File: 2014/1778

**RE: BCA Assessment – DA Submission R4.0
Taronga Zoo Sumatran Tiger Adventure**

1.0 Introduction

FIGURE 26(A) STAIRWAY LOCATION AND HANDRAIL EXTENSIONS AT BOUNDARY

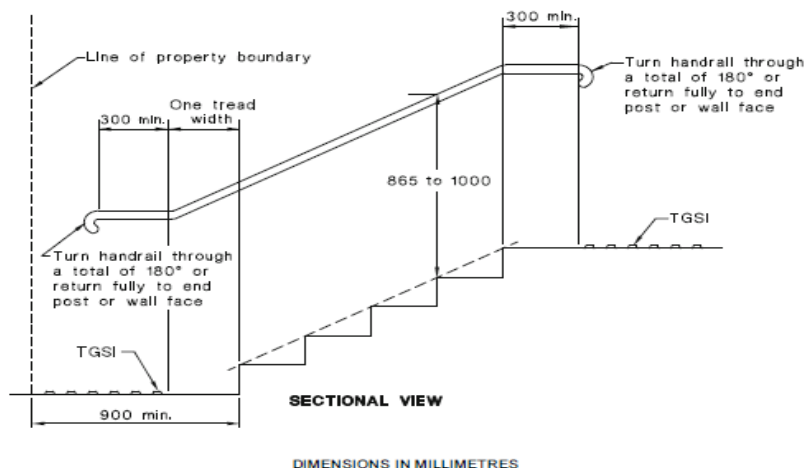
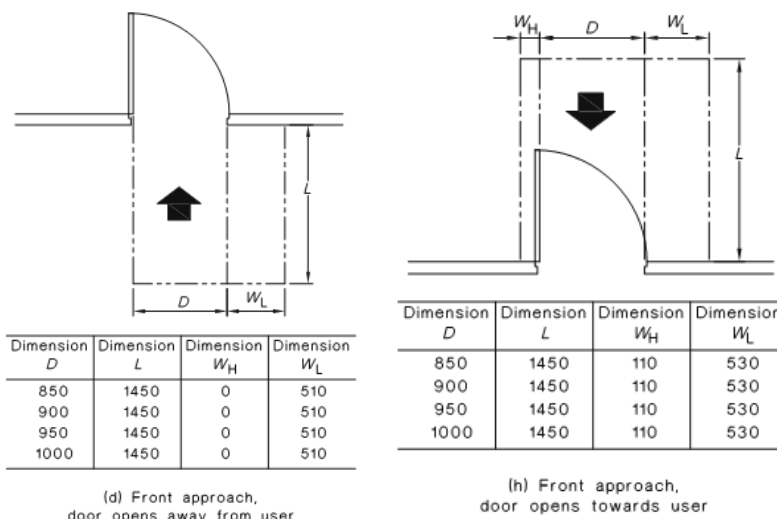
4.	The threshold of the entry and exit doorway of the building must not incorporate a step in accordance with Clause D2.15.
5.	The stairway entry is required to have handrails to both sides and tactile indicators as shown in the below diagram from AS1428.1-2009:

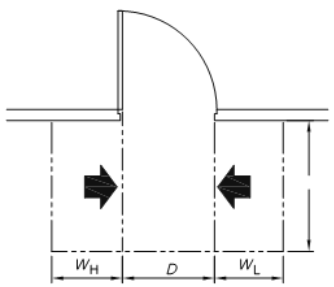
6. The exit doorway is required to have door circulation spacing in accordance with Figure 31 of AS1428.1-2009. Required door circulation is shown below:

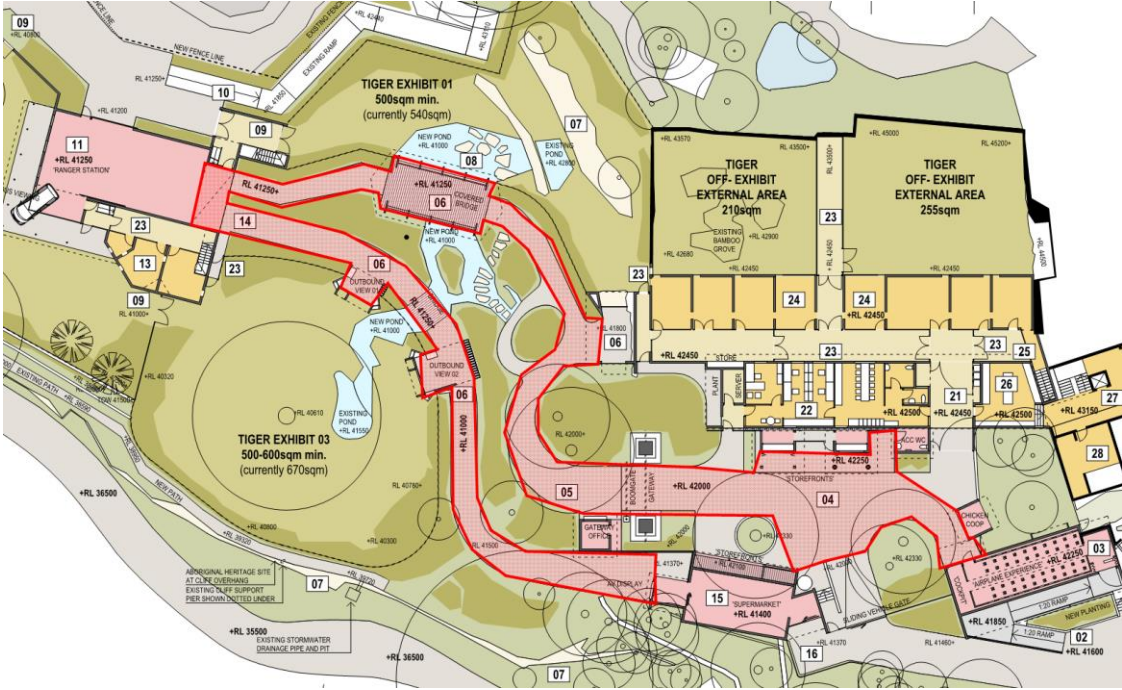
- Clause D2.19 requires the automatic sliding doors to the entry and exit to open automatically if there is a power failure to the door and have the capacity to be opened manually under a force of not more than 110N if there is a malfunction or failure of the power source.
